**10 NRC RAIS AND WESTINGHOUSE RESPONSES – WCAP-16608**

Subject: Response to NRC Request for Additional Information on WCAP-16608-P, Addendum 1, "Westinghouse Containment Analysis Methodology, Addendum 1 Appendix C, PWR LOCA Mass and Energy Release Input Calculation Methodology" (Proprietary/Non-Proprietary) dated May, 2008

Figure 15: Long-term Containment Pressure for DEPS LOCA

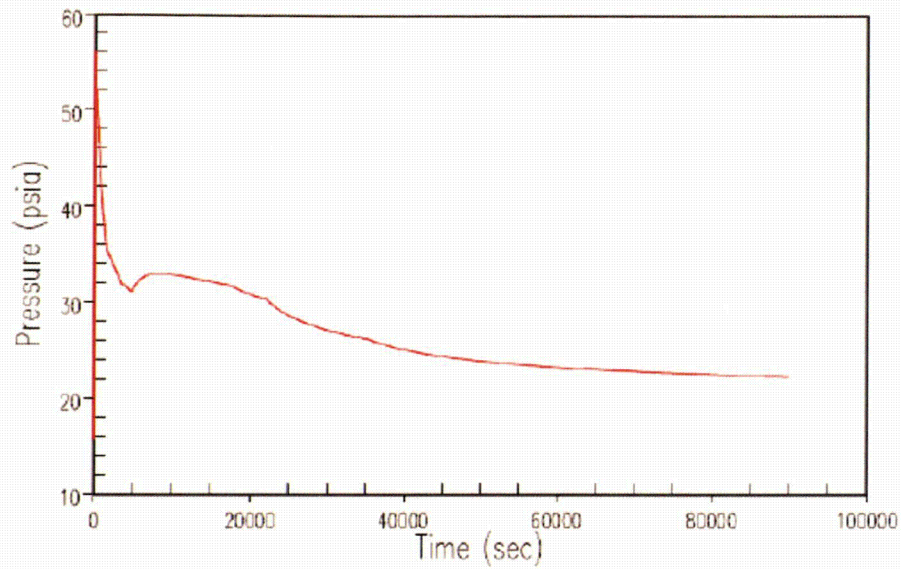
Figure 6-2 shows that the containment pressure, especially for double-ended pump suction (DEPS) case, is rising after 5000 sec. Provide 24-hour (86400 seconds) containment response for both DEPS (Section 5.3) and double-ended hot leg (DEHL) (Section 5.4) cases. Provide the analysis procedure (methodology) to assure the adequacy of containment heat removal system by demonstrating, for example, that the containment pressure will be below 50% of peak pressure after 24-hour into LOCA (NUREG-0800, "Standard Review Plan 6.2.2," "Containment Heat Removal Systems.").

The LOCA M&E calculation for the long-term equipment qualification (EQ) application is biased to maximize the calculated long-term containment pressure and temperature. The biasing for this application is described in Section 4.2 of WCAP-17721-P and the corresponding containment response for the DEPS, DECL, and DEHL cases is shown in Figures 6-1 and 6-2. As shown in Figure 6-1, the calculated pressure for the DEHL case increases the fastest during blowdown phase, but continues to decrease after the end of blowdown and becomes less than the DEPS and DECL cases after about 300 seconds.

]<sup>3,c</sup>. Therefore, the calculated containment pressure for the DEHL case will always be lower than the DEPS or DECL cases within a short period of time after the end of blowdown. This is confirmed in Figure 6-2. Figure 6-2 also shows that the calculated pressure for the DEPS and DECL cases is less than 50% of the peak by 3000 seconds, but starts trending upward just before 5000 seconds.

Figure 6-12 in Section 6.2 shows that the calculated pressure for the DEPS case levels off at about 33 psia, which is still less than 50% of the peak pressure, then continues to trend downward out to 50000 seconds as the core decay heat continues to decrease. As shown in Figure 15, this case was extended to 24 hours to demonstrate that the containment pressure would remain less than 50% of the peak at 24 hours after the LOCA event.

Figure 16: Integrated DEPS LOCA Mass Release Comparison

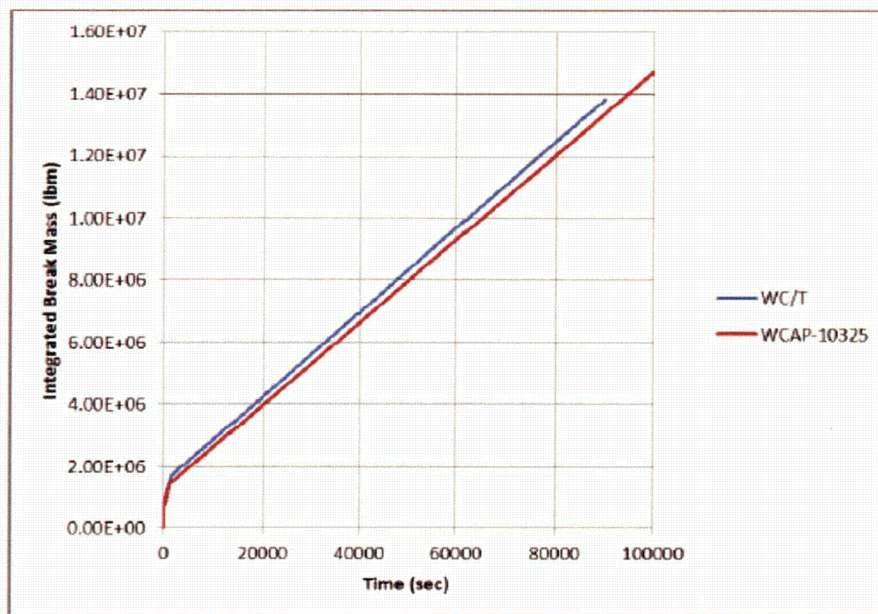
Please provide the integrated mass and energy release from break up to 24-hour (86400 seconds) for Figures 5-7 and 5-8; similarly, for DEHL case (Section 5.4).

The integrated mass and energy release comparison for the DEPS case has been extended out to 24 hours and is shown in Figure 16 and Figure 17. After 5400 seconds (the end of the WC/T calculation), the DEPS case mass and energy releases are calculated following the method that is described in Section 4.2 of WCAP-17721-P. The integrated mass release comparison shows that the mass release from WC/T remains higher than the benchmark case after about 1000 seconds. This is because WC/T calculates the recirculation time to begin about 300 seconds later than the time that was assumed in the benchmark case. The integrated energy release comparison shows that the energy release from WC/T is lower than the benchmark until about 20000 seconds. This is because WC/T calculates lower steam generator and metal energy release rates than were assumed in the benchmark case. Because the initial stored energy in the WC/T model is slightly higher than the benchmark case, the integrated energy release remains slightly higher after 20000 seconds.
